PRODUCT CHANGE NOTIFICATION (PCN)

AMJE0909-0700-GYB-24
MODULAR CABLE

CHANGE NOTIFICATION: PCN 20220509_AMJE0909-0700-GYB-24

DESCRIPTION OF CHANGES:
CHANGE OF DATA SHEET
CHANGE OF DATA SHEET
New Draw.-No. ASS_7945_CArev02

AMJE0909-0700-GYB-24 OLD VERSION

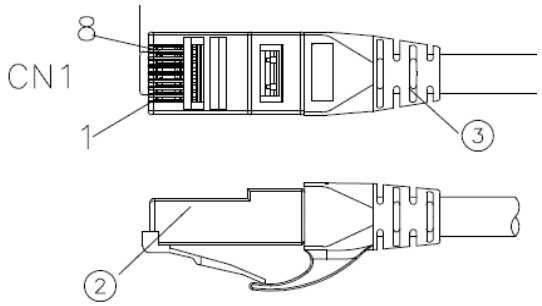
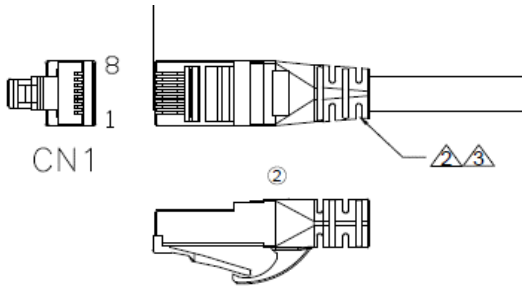
③	Molding	PVC 45P Color: see order code	NA	KG
②	CONNECTOR	RJ45 8P8C two fork Short type 3u" gold plated	2	PCS
①	CABLE	CAT6 UTP (24AWG*1PR)*4+PVC OD=5.8±0.3MM Color: see order code	NA	MM
NO:	NAME	DESCRIPTION	Q'TY	UNIT

3	Molding	PVC 65P Color: see order code ②	NA	KG
2	CONNECTOR	RJ45 8P8C PLUG 3u" gold plated ②	2	PCS
1	CABLE	CAT6 U/UTP (24AWG*1PR)*4+Cross+PVC Jacket OD=5.8± 0.3MM Color: see order code ②	NA	MM
NO:	NAME	DESCRIPTION	Q'TY	UNIT

Drawing-No.
ASS 7945 CA

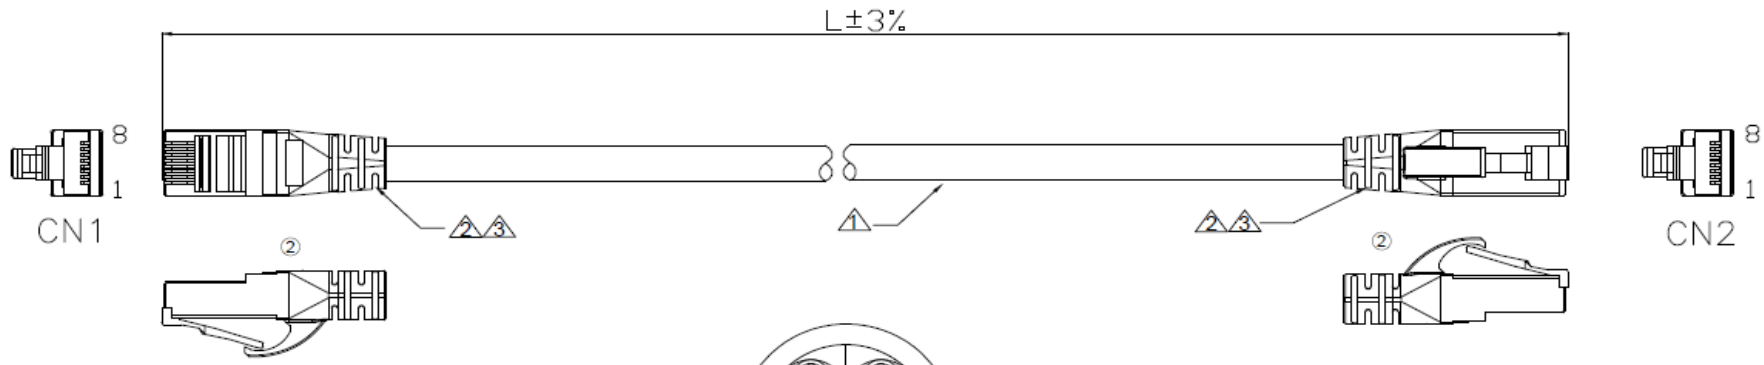
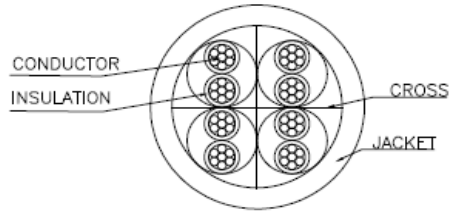
Id.	Modification	Date	Name
②	Change the plant	09.05.2022	Luca
①	Update the WSW order code	02.06.2017	Amy
⓪	Drawn	30.03.2017	Amy

NO:	NAME	DESCRIPTION	Q'TY	UNIT
3	Molding	PVC 65P Color: see order code ②	NA	KG
2	CONNECTOR	RJ45 8P8C PLUG 3u" gold plated ②	2	PCS
1	CABLE	CAT6 U/UTP (24AWG*1PR)*4+Cross+PVC Jacket OD=5.8± 0.3MM Color: see order code ②	NA	MM
